Service Bulletin

VARIOUS AUDIO SYSTEM CONCERNS WITH TUNER AND AMP UNIT (TAU)

Bulletin No: 09-021/14

Last Issued: 06/27/2014

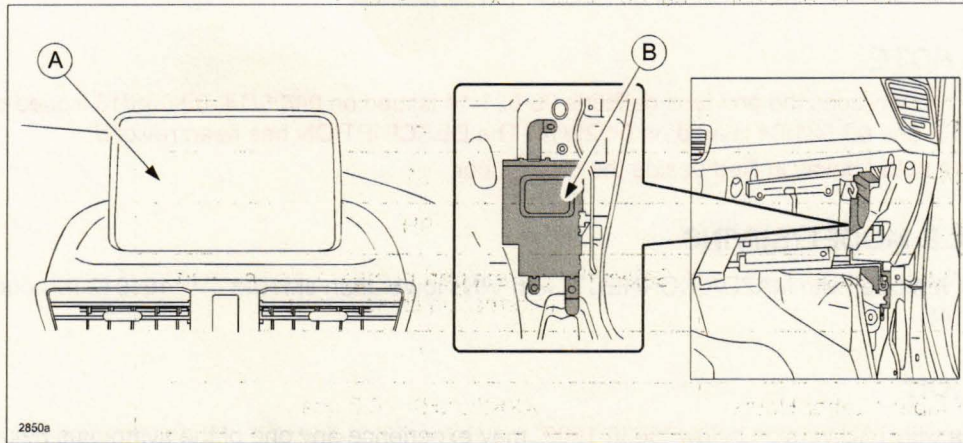
Some vehicles with TAU version below "3030 1903" may experience any one of the symptoms below that can be resolved with a modified TAU.

- AM/FM/XM cannot be selected as they are grayed out
- Radio station returns to 87.9MHz on its own
- Audio sound setting resets on its own
- TAU version is displayed as "not available"
- Volume of FM stations changes while driving when there is poor reception

1. Verify customer concern.
2. On vehicle with a touchscreen (A), remove the TAU (B) and replace with a modified one. Refer to MS3 online instructions or Workshop manual (section 09-20 TUNER AND AMP UNIT (TAU) REMOVAL/INSTALLATION).
